INSPECTION REPORT

Permit Number: SPRNR230582

Property Address: 1716 COPPER RIDGE SPUR, UNIT:C1;

On this day we have inspected your construction for **Final Planning Department Site Improvement** and we find the following result of the inspection. If there are any questions, please call the inspector at the address below.

SITE PLAN

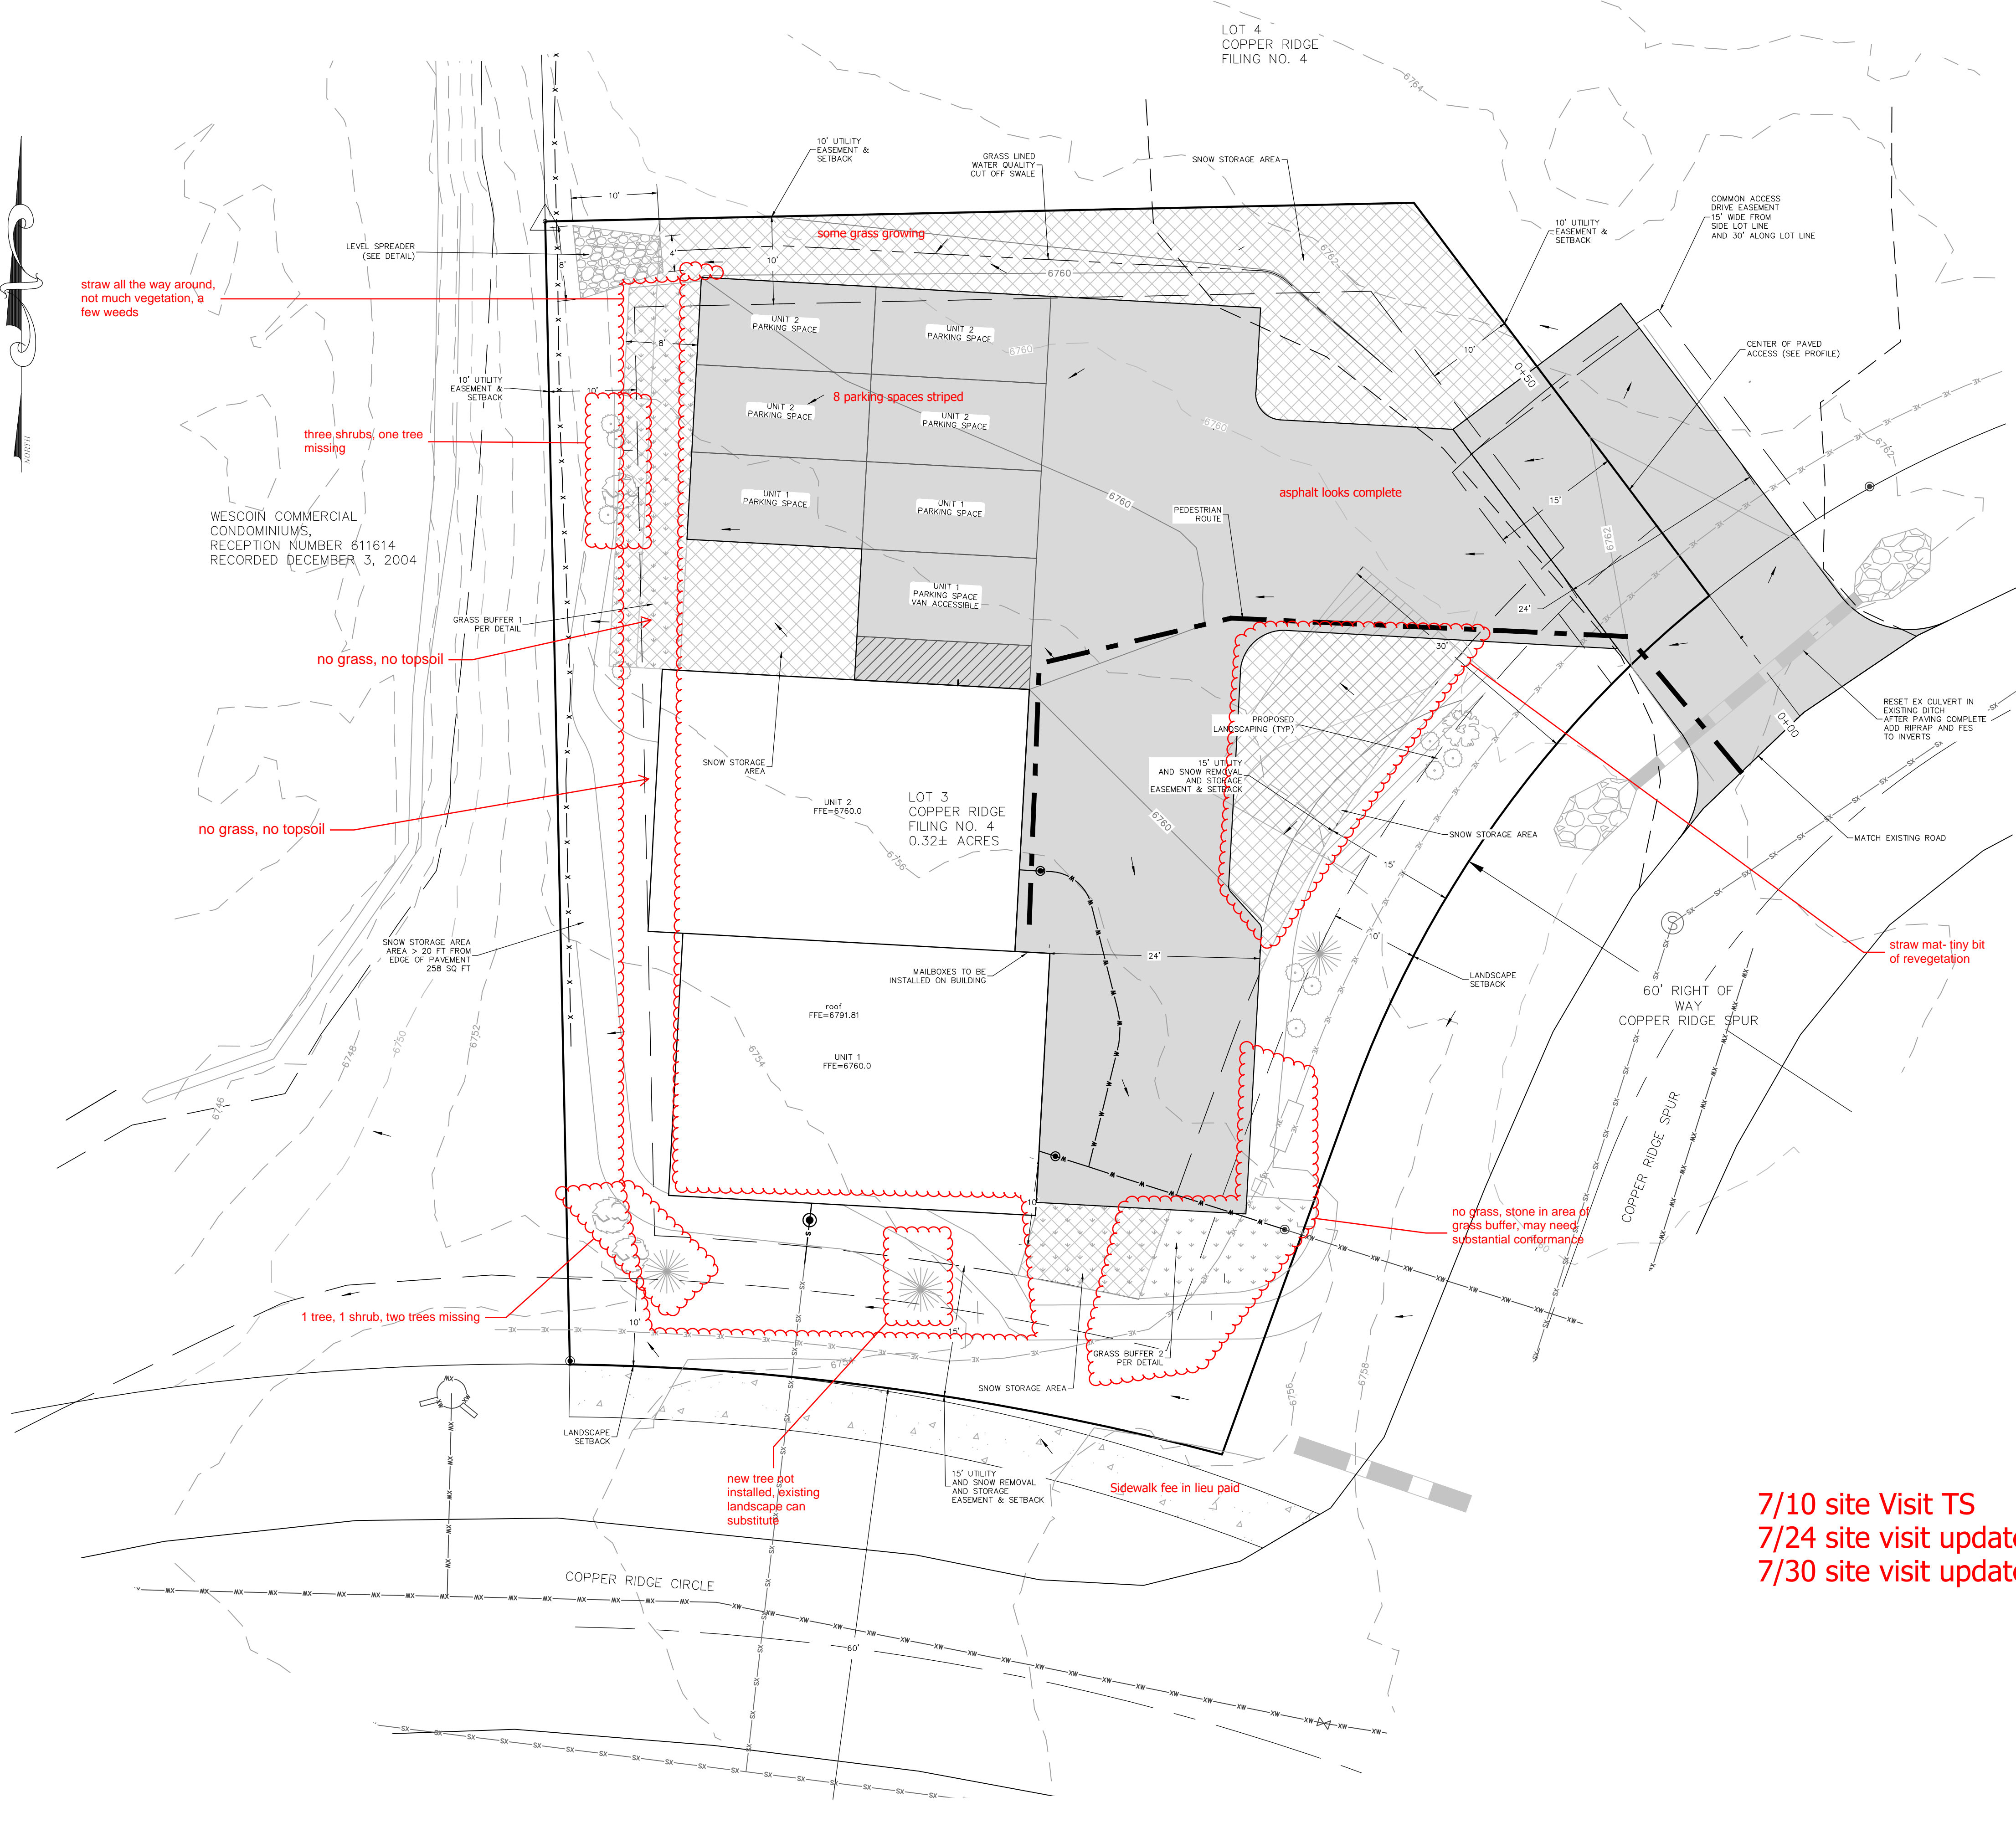
- 1 See site plan notes
- 2 Critical improvements are incomplete, see conditions on PL20220235
- 3 Revegetation needs to be reviewed and approved by Engineering/Stormwater. If that department approves of the site they can resolve conditions on the DP or the BP, upload a letter, or let me know and I can resolve my comments
4. The grass buffer/drainage area on the front of the property called out on the site notes also needs to be reviewed/approved by Engineering. If the DP needs to change to be consistent with the BP, a substantial conformance plan is required.

straw all the way around, not much vegetation, a few weeds

three shrubs, one tree missing

no grass, no topsoil

no grass, no topsoil

1 tree, 1 shrub, two trees missing

new tree not installed, existing landscape can substitute

no grass, stone in area of grass buffer, may need substantial conformance

straw mat- tiny bit of revegetation
